Application for Licence Amendment

Licence Number	L9013/2016/1
Licence Holder	Gascoyne Resources Limited
ACN	139 522 900
File Number	DER2016/002214
Premises	Dalgaranga Gold Project Legal description - Mining Lease M59/749 and Miscellaneous Licence L59/151 DAGGAR HILLS WA 6638
Date of Report	29 August 2023
Decision	Revised licence granted

Figure 1: Golden Wings Integrated Waste Landform and Monitoring Bores

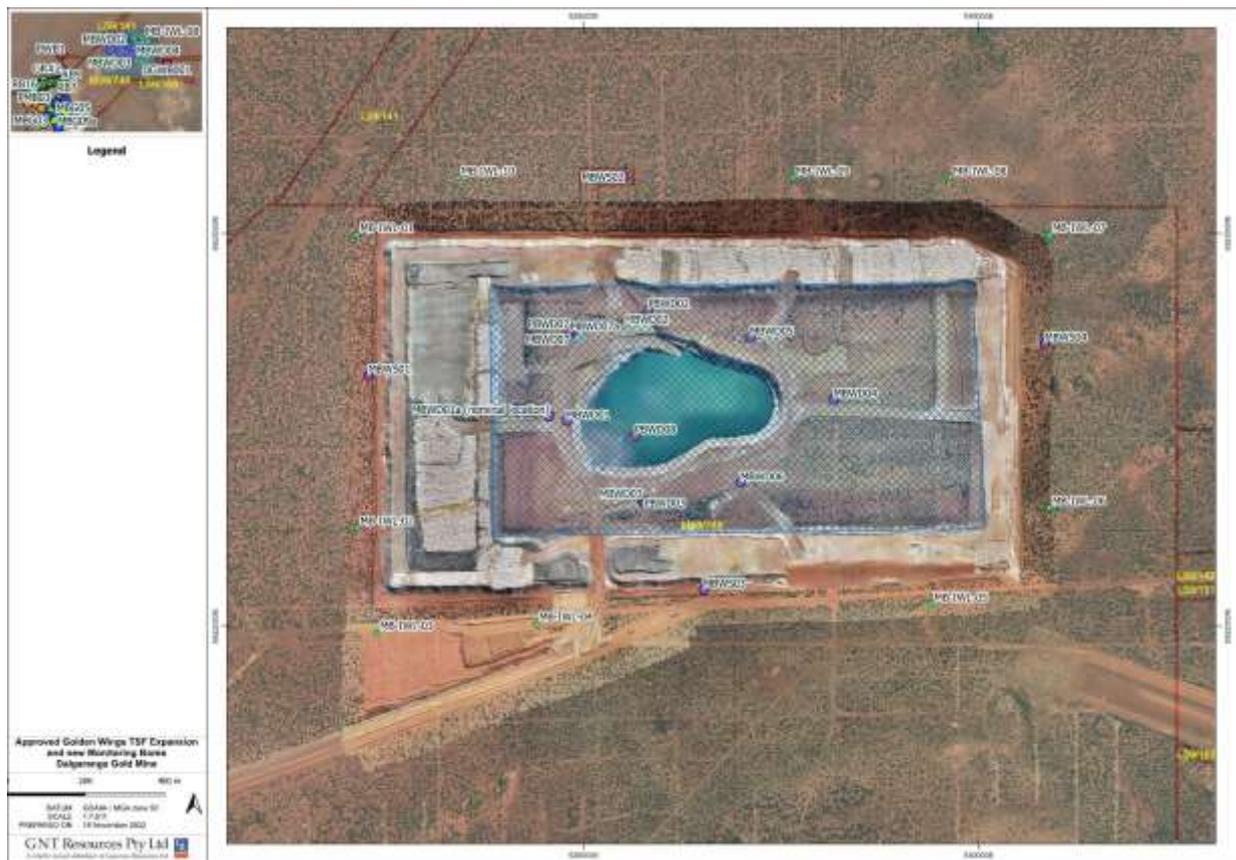
Ten new groundwater monitoring bores (MBIWL01, MBIWL02, MBIWL03, MBIWL04, MBIWL05, MBIWL06, MBIWL07, MBIWL08, MBIWL09 and MBIWL10) surrounding the TSF have been installed under works approval W6693/2022/1. Refer to Figure 1.

Assessment of the new groundwater monitoring bores as part of the Construction Report found the bores were constructed at an inappropriate depth. The Construction Report was forwarded to DWER's Senior Hydrogeologist for technical advice who advised that they will be suitable for monitoring groundwater mounding that would be associated with seepage from the TSF.

However, they are likely to be less suitable for monitoring changes in groundwater quality caused by seepage from the facility (although it is recommended that groundwater sampling is still undertaken from these bores).

Groundwater trigger levels for these bores should be set at the base of the local root-zone and at a depth of about two metres below this depth. If the lower trigger level is exceeded, it is recommended that ground-based geophysical investigations are carried out to determine the full spatial extent and depth of groundwater contamination that has been caused by seepage from the TSF.

The results of the geophysical investigations should then be used to select sites for additional monitoring bores that would be screened at an appropriate level in the saprock aquifer, and possibly also in fracture zones in the underlying bedrock. Information from these additional monitoring bores should then be used to determine suitable management responses to the groundwater mounding and contamination issue.
